RE: Proposed Dollar General Store  
Development Plan Control #201503020009

We received the development plan application review letter dated March 13, 2015. The following responses are provided to assist in the review of the enclosed re-submittal documents.

# DOLLAR GENERAL - GROVE CITY, OH (HOME RD)

03/24/15  
Sheet  
**C-1**

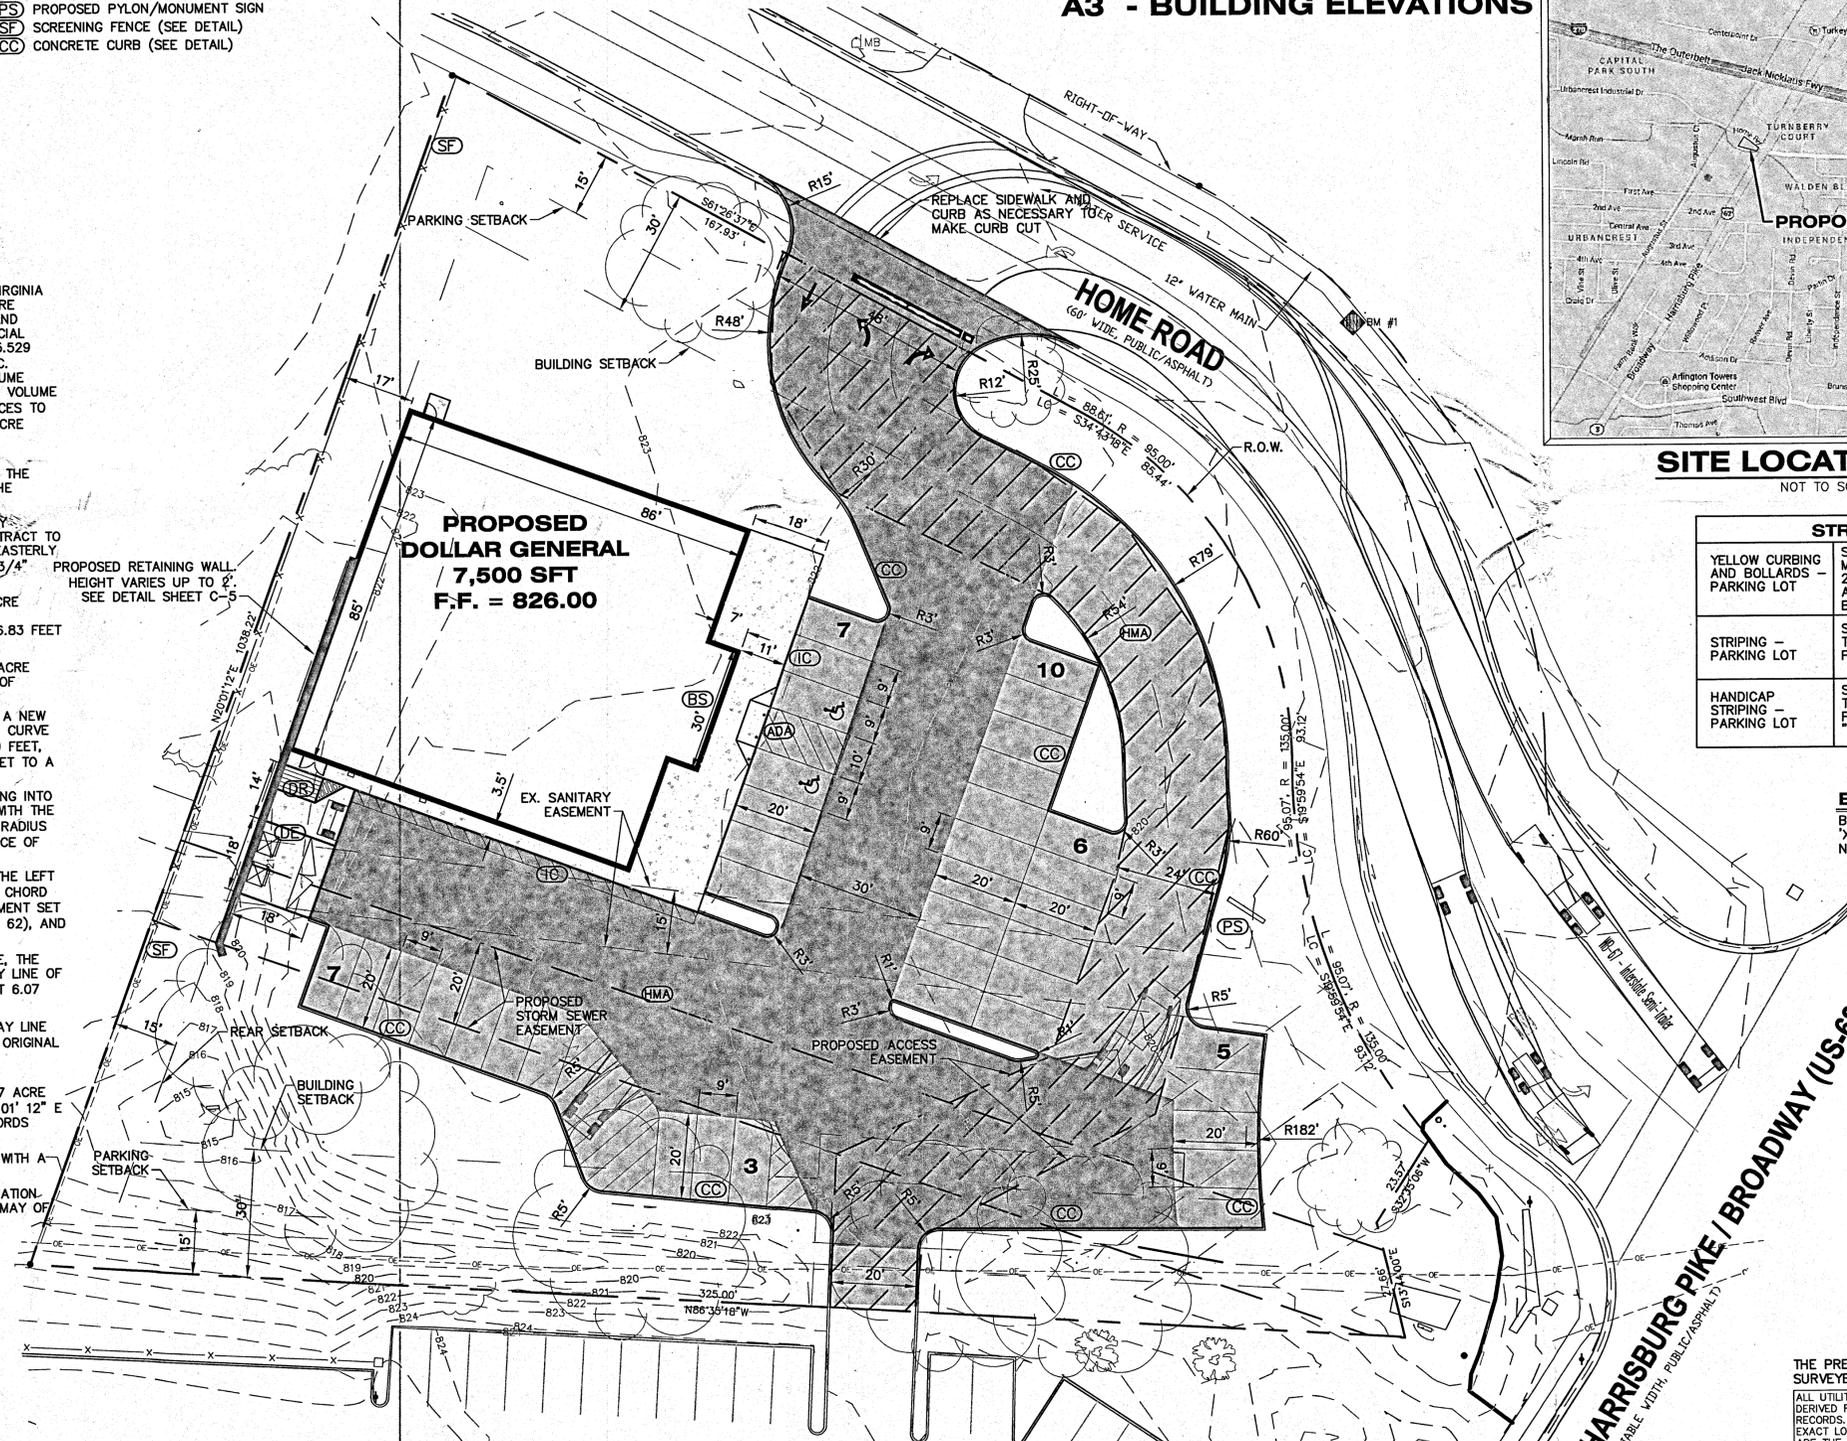
12. Turn lanes and arrows on Home Road are shown on Sheet C-1.
  13. The right-of-way and existing entrances on the north side of Home road are shown on Sheets C-1 through C-4.

19. The 824 contour has been updated to show "Base Flood Elevation".
  20. The proposed access easement is shown and labeled on Sheet C-1.

**C-2**

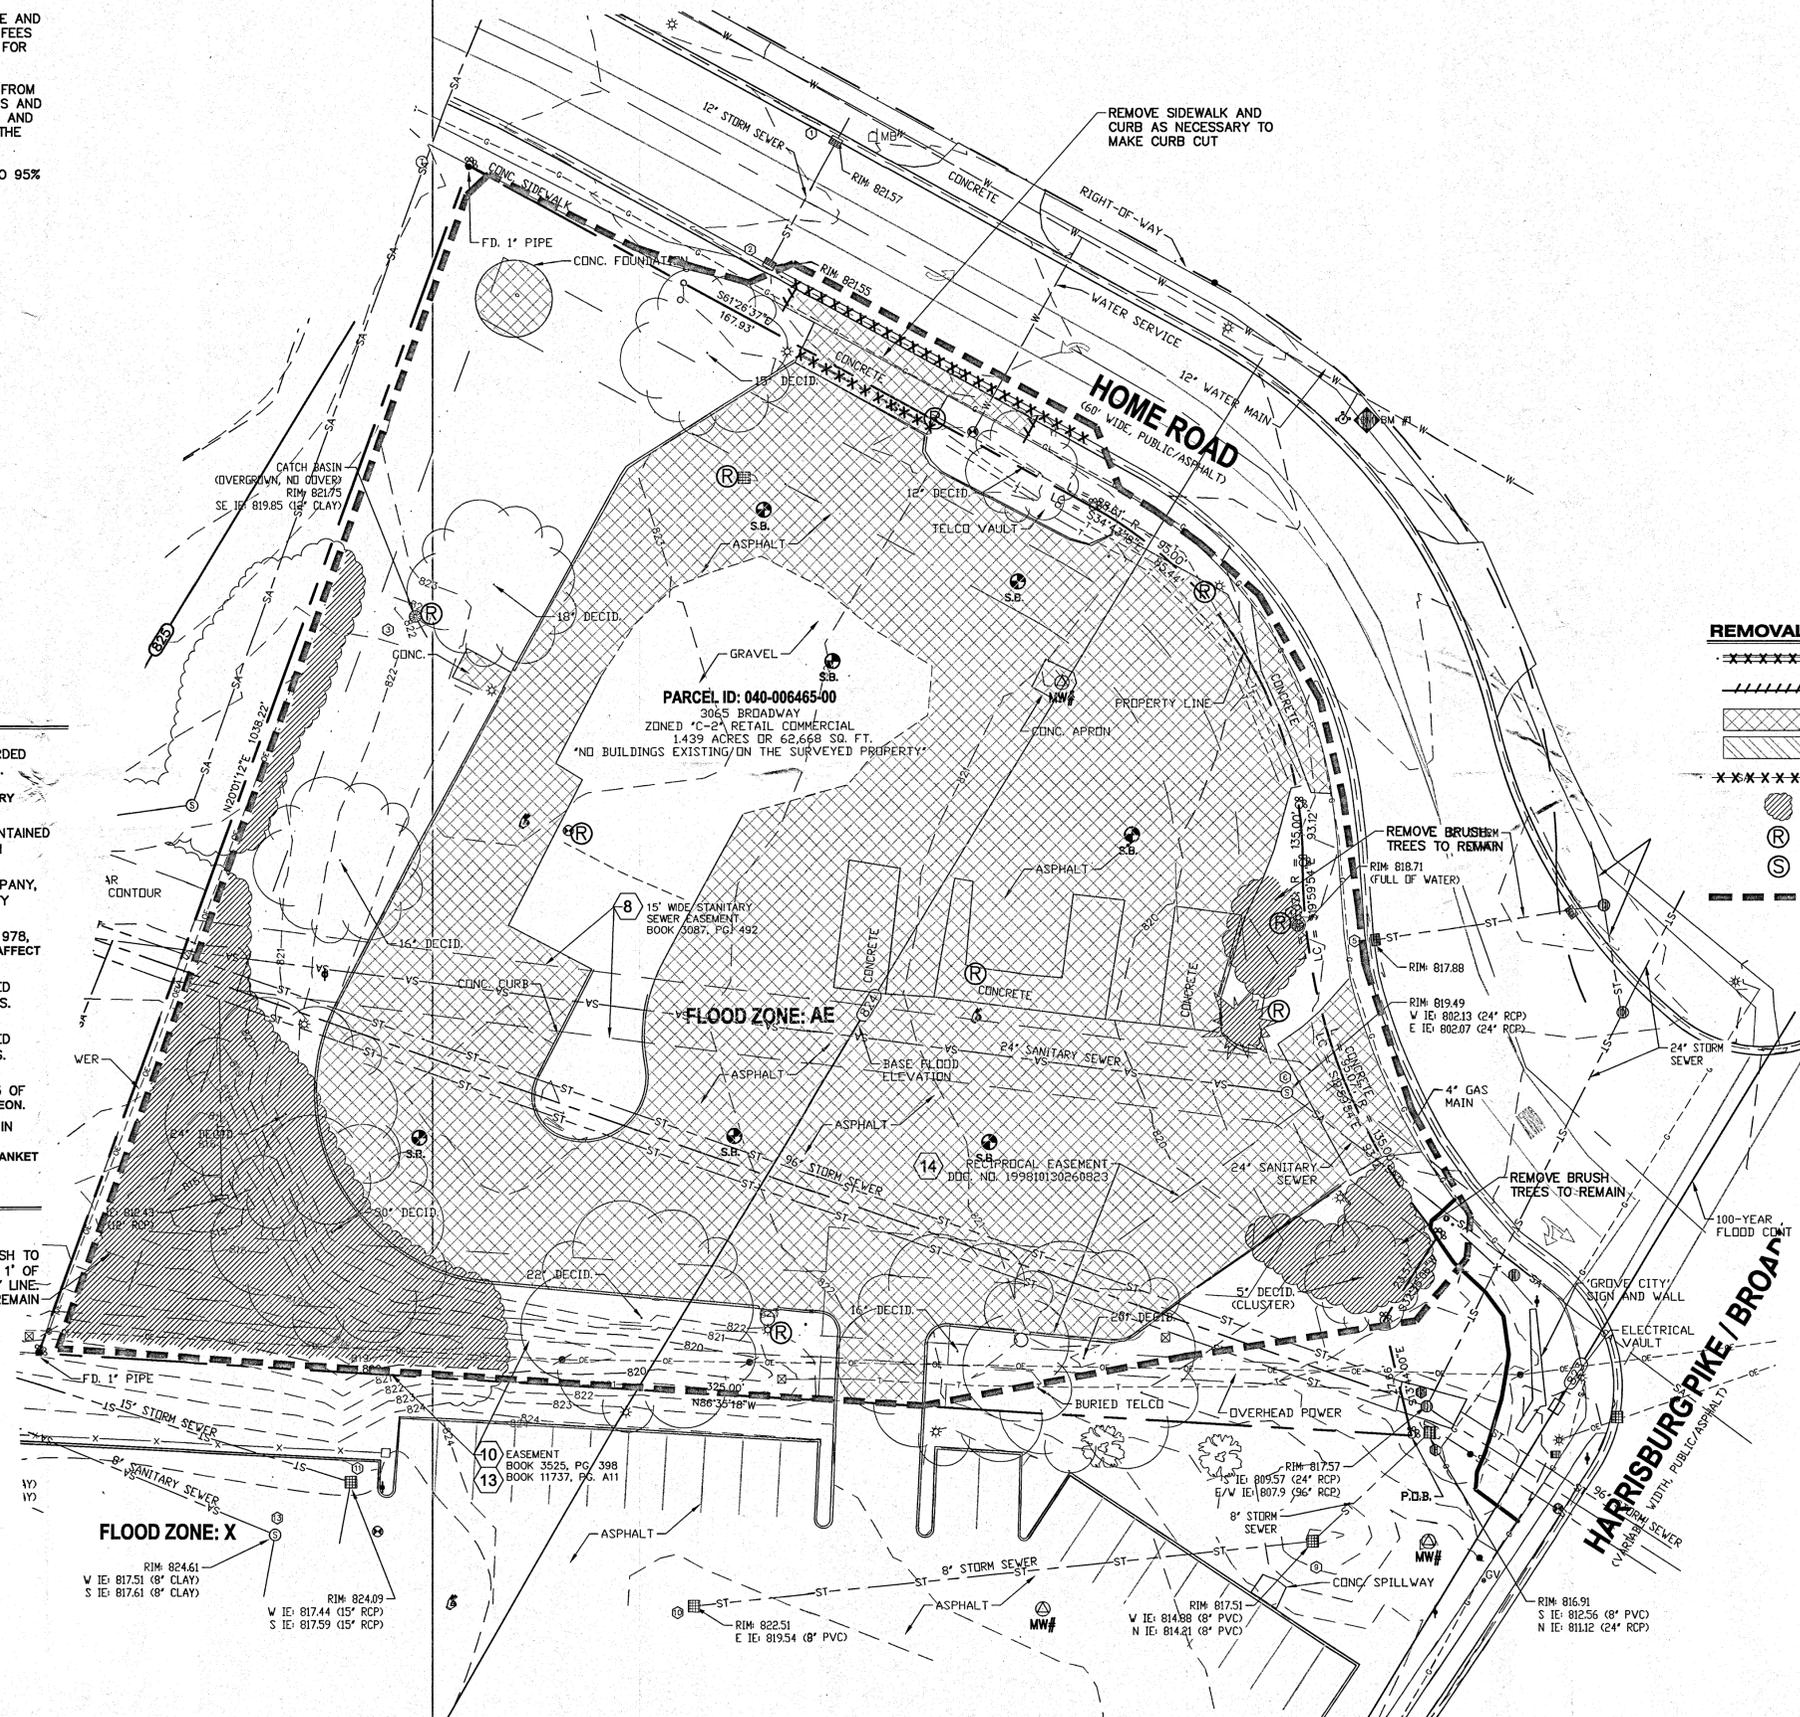
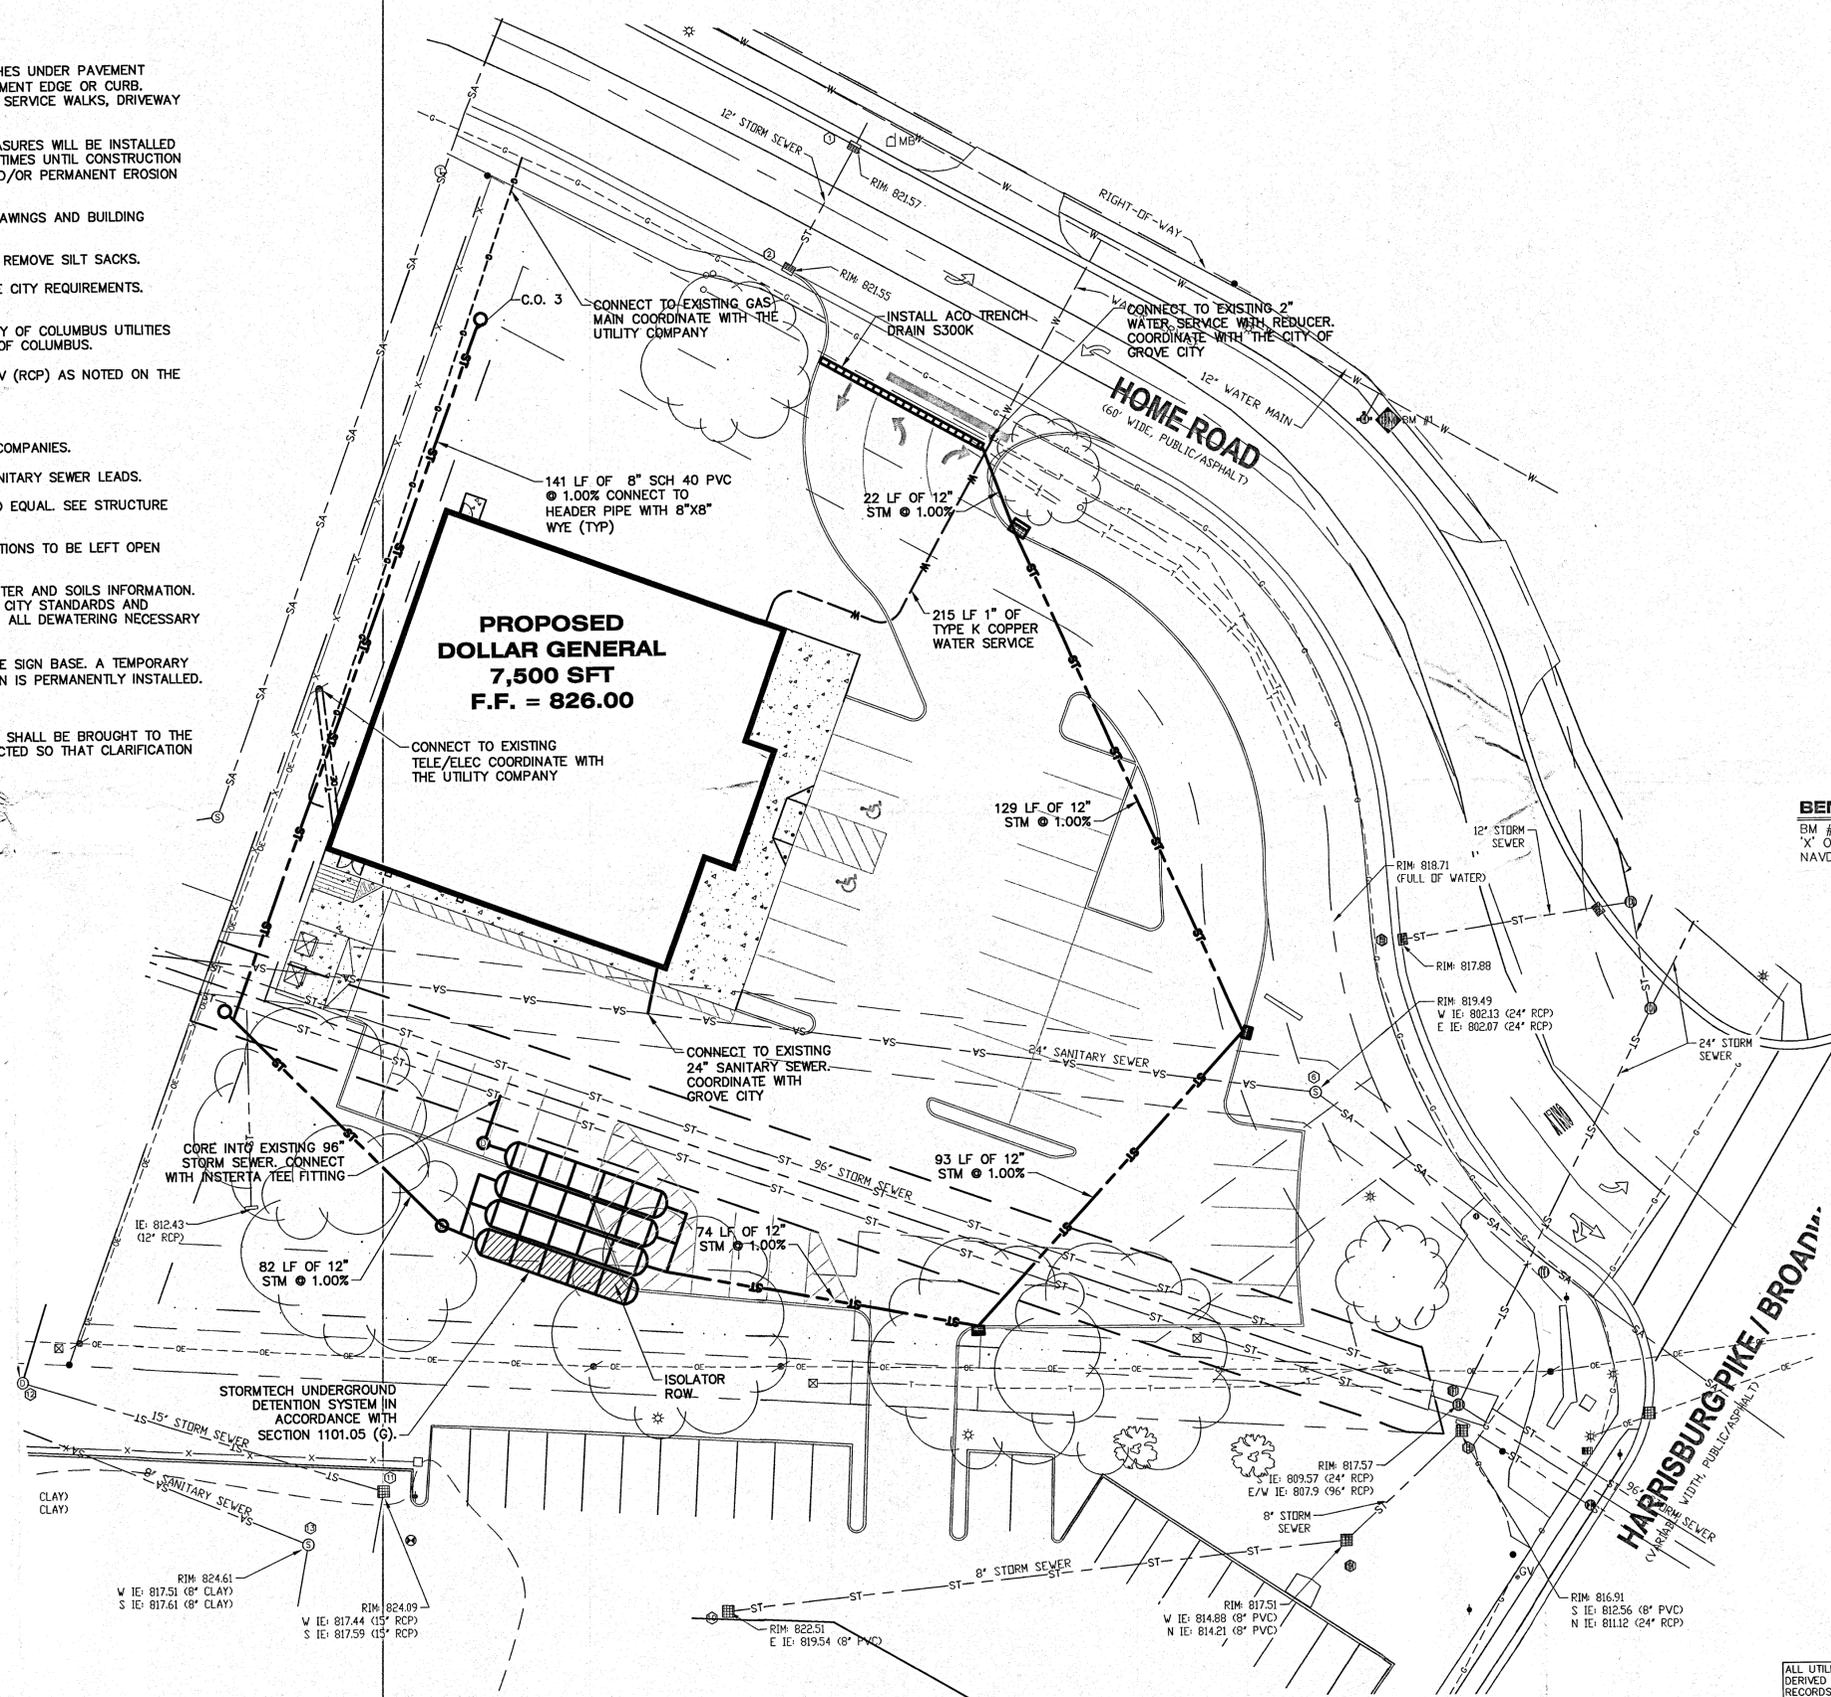
10. Sheet C-5 has been revised to show a handicap parking stall width of 9 feet.
11. Our discussions with the Grove City Building Department determined that the site is not within the Floodway as Baumgardner Ditch has been enclosed. The floodplain (base

- flood) elevation is shown on Sheet C-2. A Special Flood Hazard Are Permit will be submitted for through the Building Department once the site plan is approved.

14. The existing water main and size are now shown on Sheets C-2 and C-3.
  15. The datum for the benchmark is shown on Sheet C-2.
  16. A note stating "Storm water retention in accordance with Section 1101.05 (g)" has been added to Sheet C-3.
